## BH\_CROSSROADS\_TO\_REDMOND\_RIDGE\_MSC

UNDERGROUND FIBER INSTALLATION  
RIGHT-OF-WAY CONSTRUCTION PERMIT

City of Redmond  
Public Works - Right-of-Way

Approved  
Approved with Corrections noted  
Revision Required

SHEET 06 OF 17

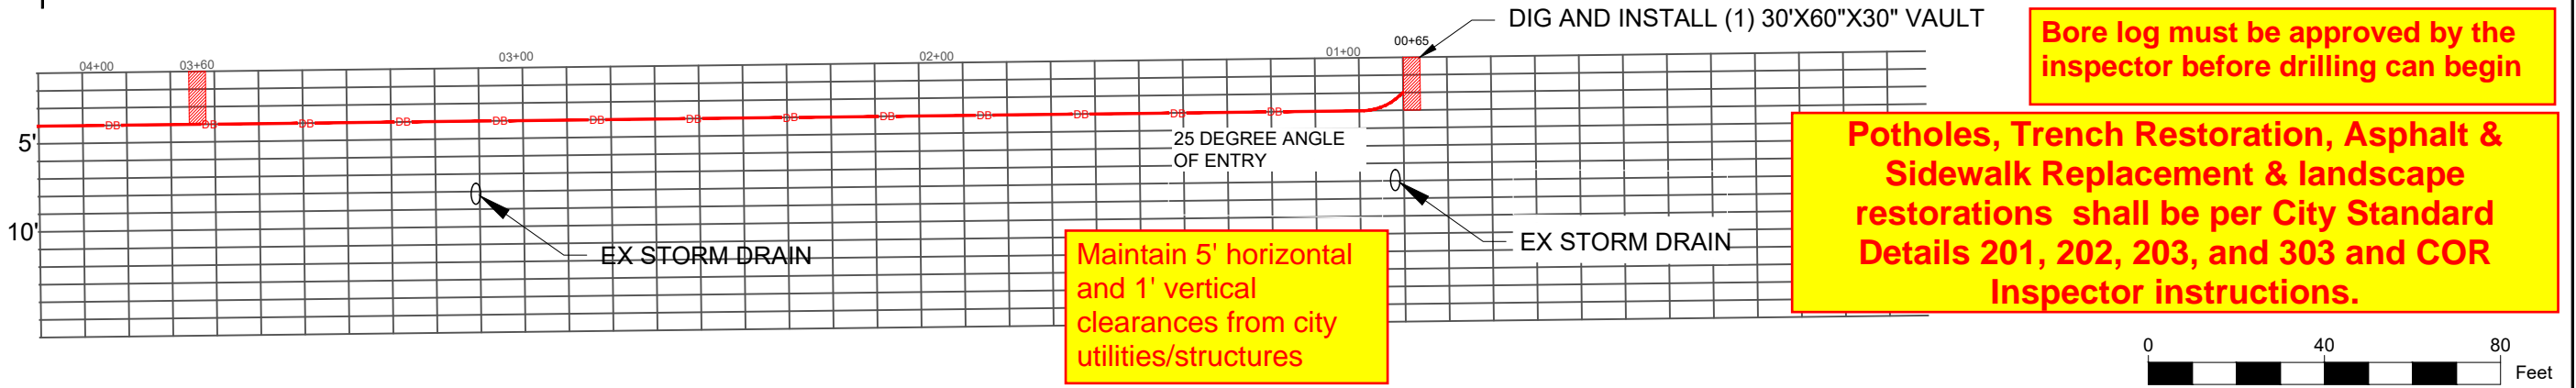
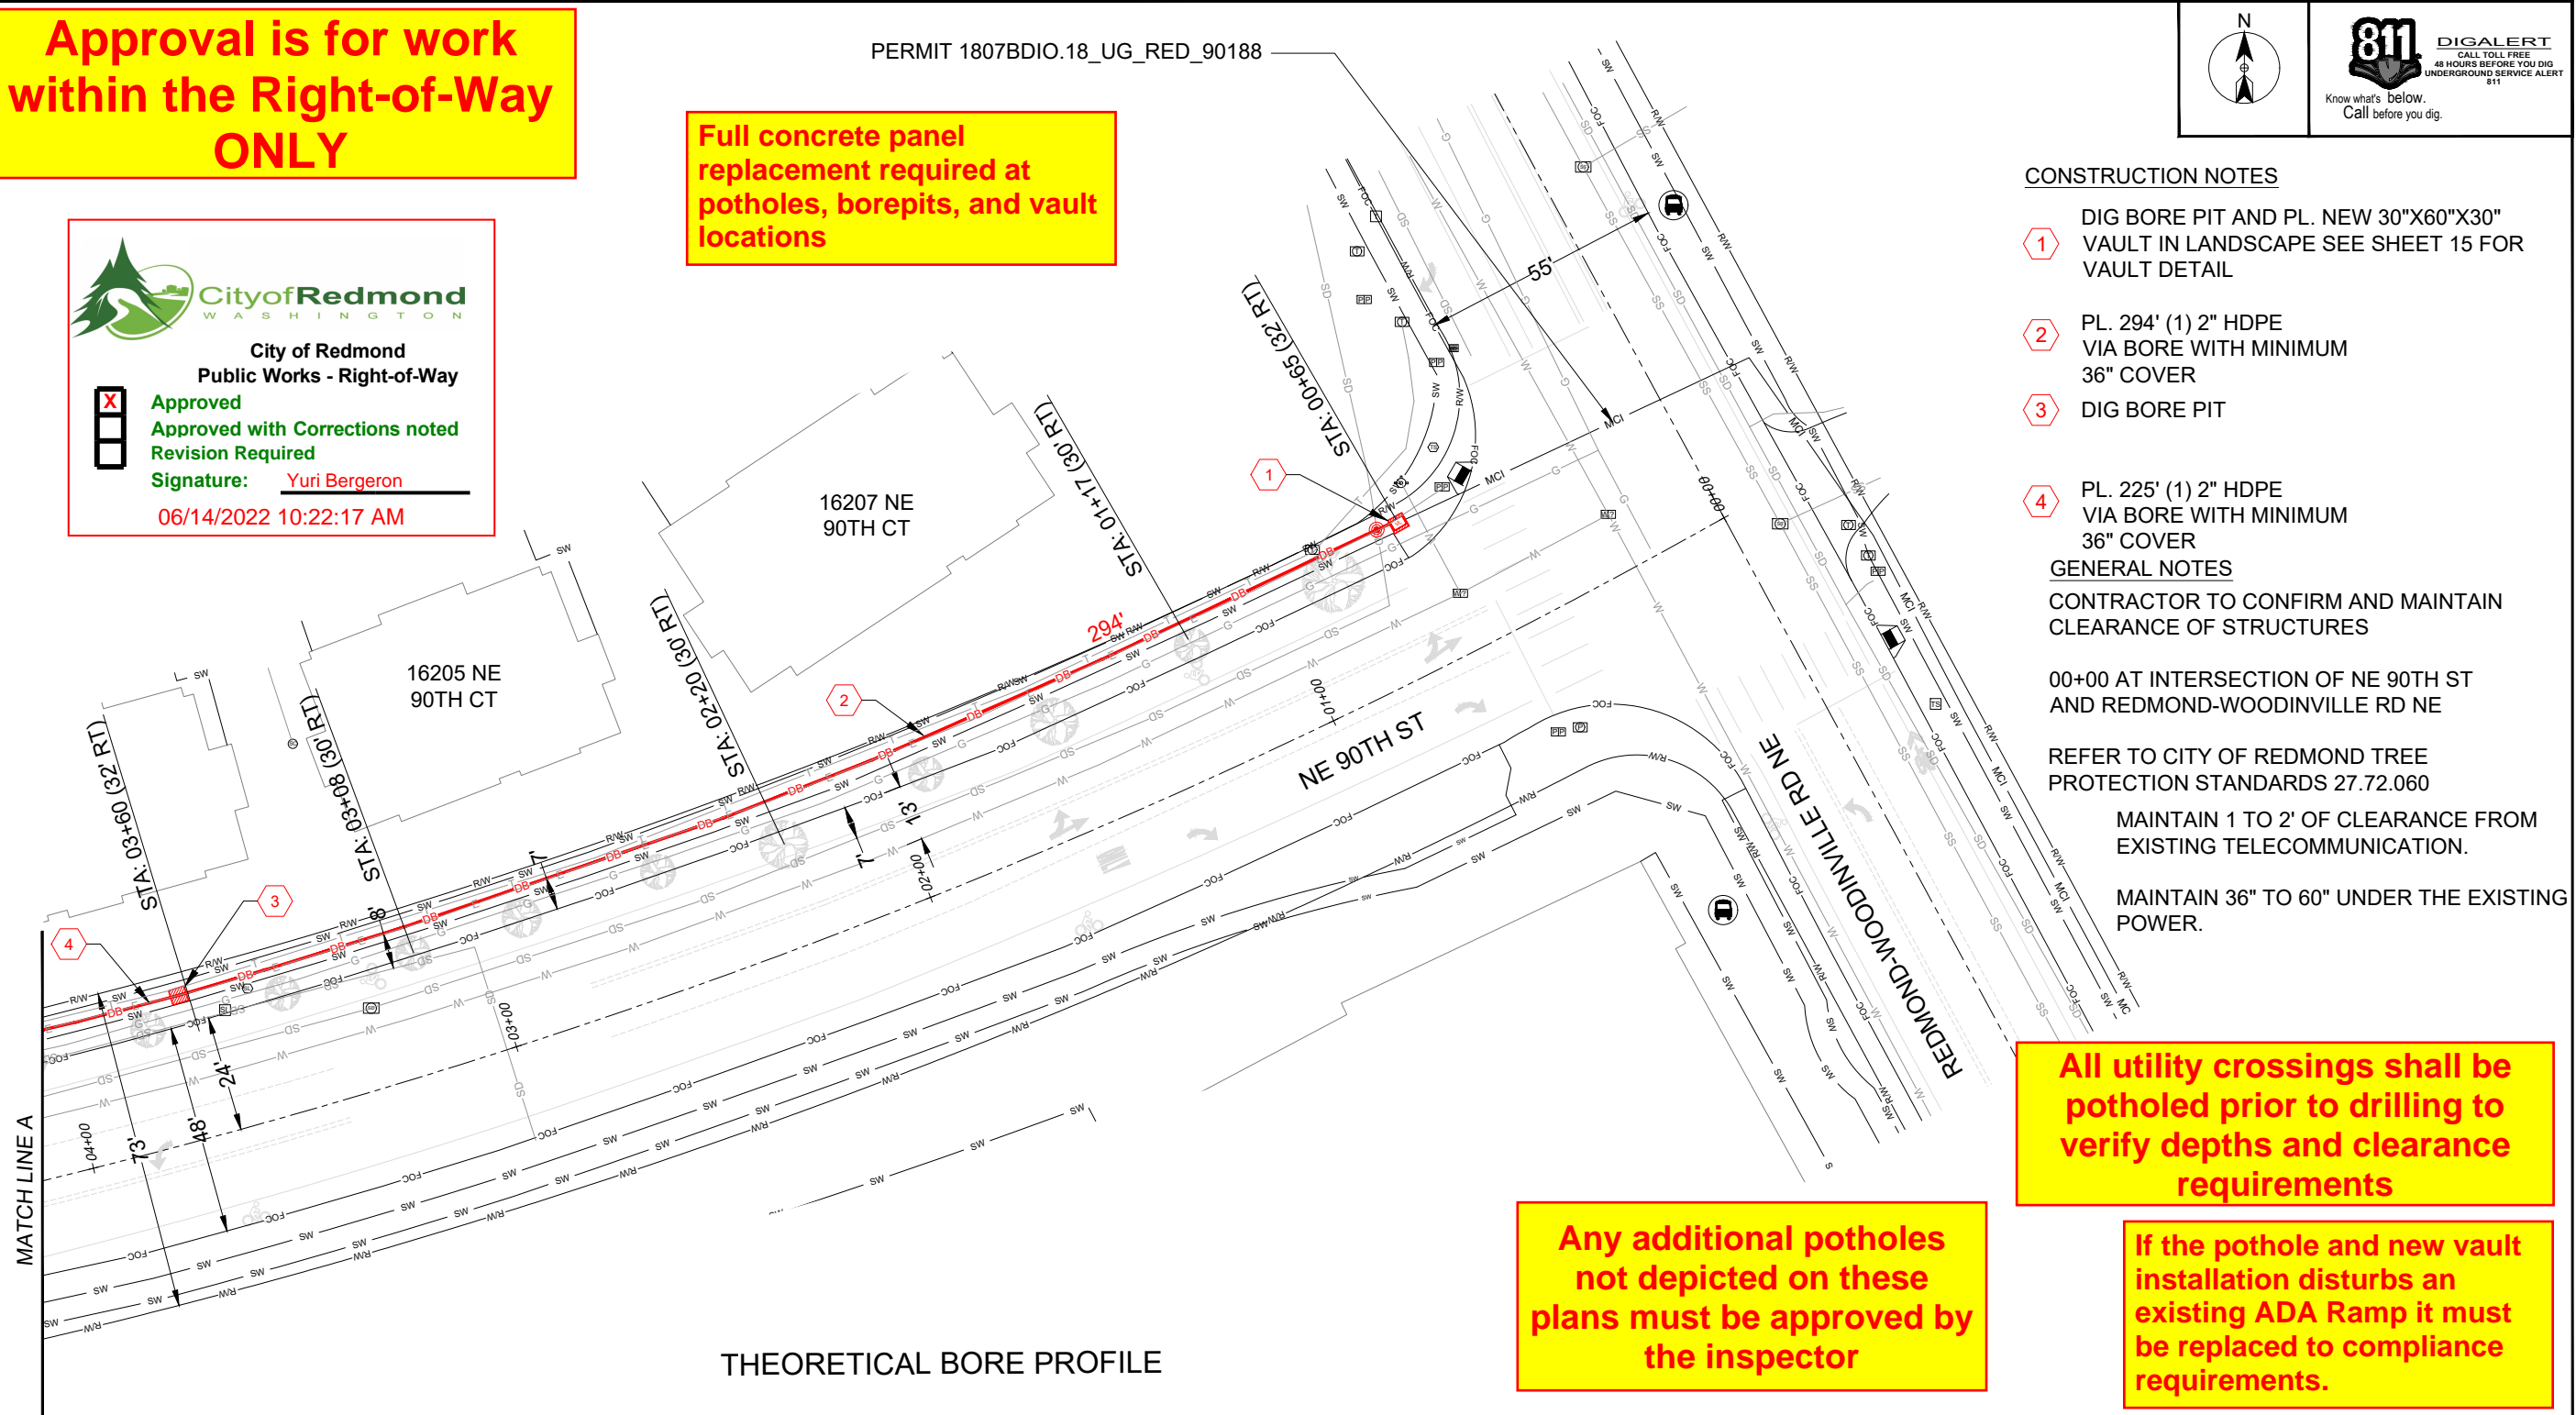
Full concrete panel replacement required at potholes, borepits, and vault locations

- All utility crossings shall be potholed prior to drilling to verify depths and clearance requirements
- If the pothole and new vault installation disturbs an existing ADA Ramp it must be replaced to compliance requirements.
- Bore log must be approved by the inspector before drilling can begin

Maintain 5' horizontal and 1' vertical clearances from city utilities/structures

Potholes, Trench Restoration, Asphalt & Sidewalk Replacement & landscape restorations shall be per City Standard Details 201, 202, 203, and 303 and COR Inspector instructions.

SCALE  
HORIZ: SEE SCALE  
VERT: 1:10  
SHEET 07 OF 17

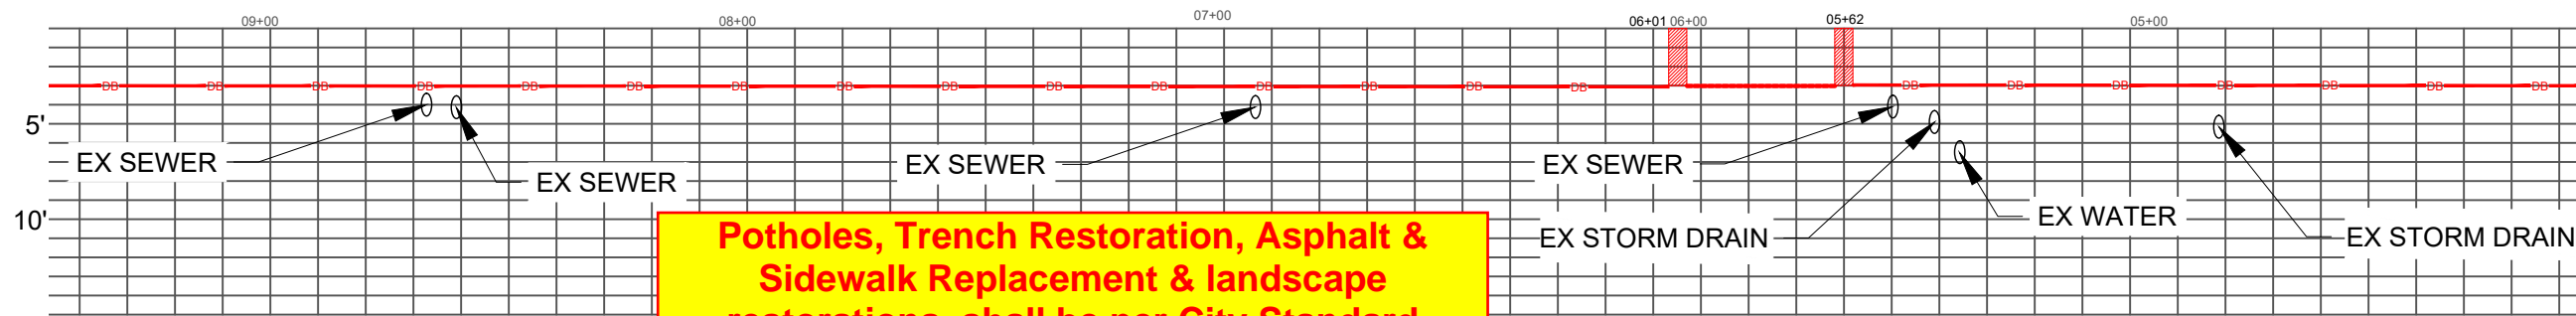
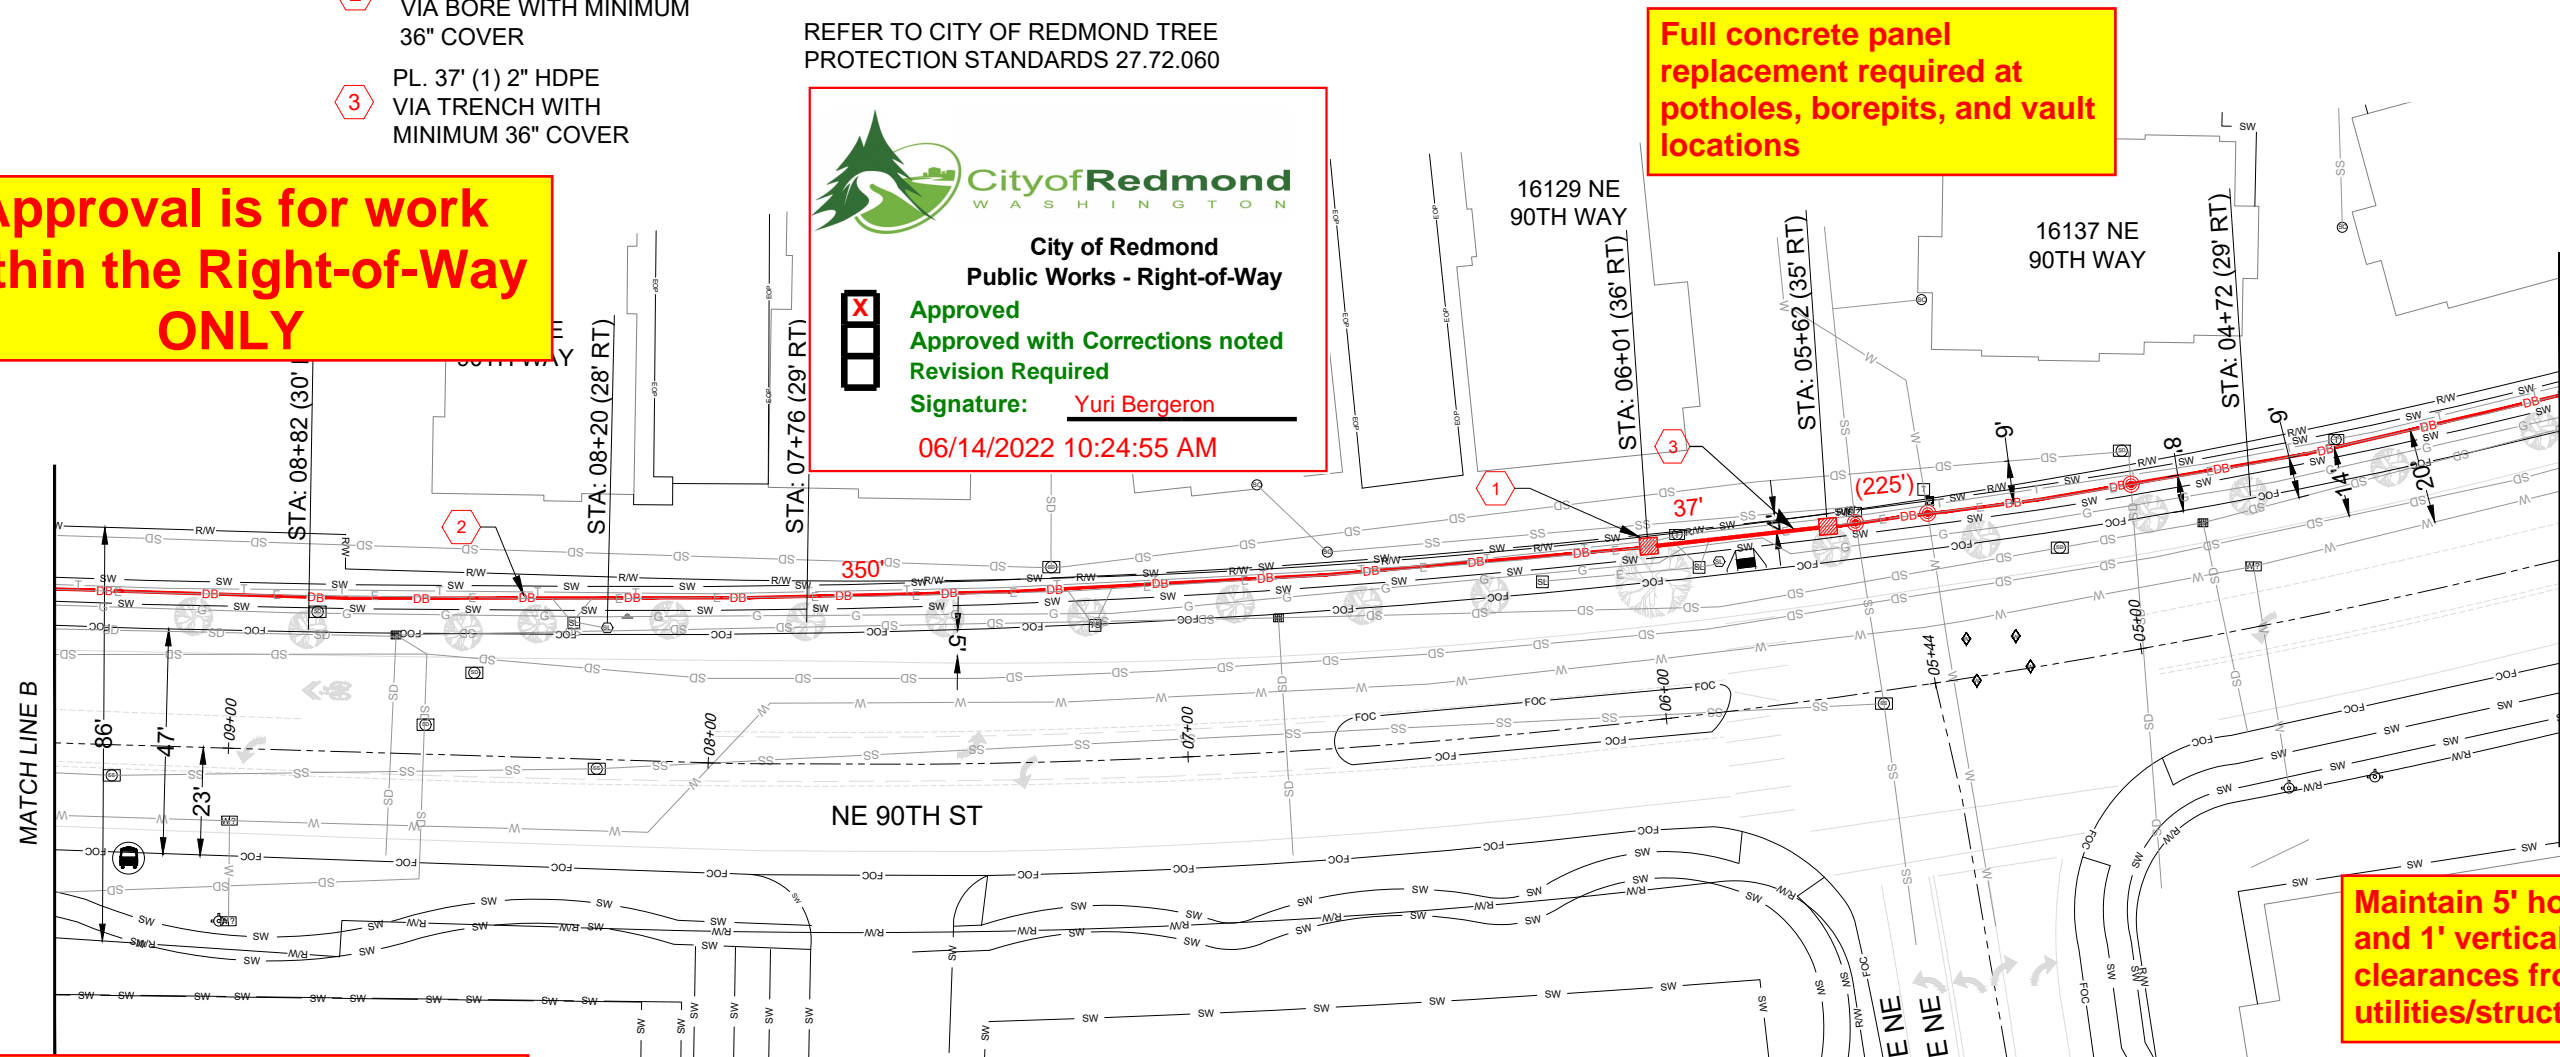
Full concrete panel replacement required at potholes, borepits, and vault locations

Maintain 5' horizontal and 1' vertical clearances from city utilities/structures

Any additional potholes not depicted on these plans must be approved by the inspector

Bore log must be approved by the inspector before drilling can begin

If the pothole and new vault installation disturbs an existing ADA Ramp it must be replaced to compliance requirements.

All utility crossings shall be potholed prior to drilling to verify depths and clearance requirements

Potholes, Trench Restoration, Asphalt & Sidewalk Replacement & landscape restorations shall be per City Standard Details 201, 202, 203, and 303 and COR Inspector instructions.
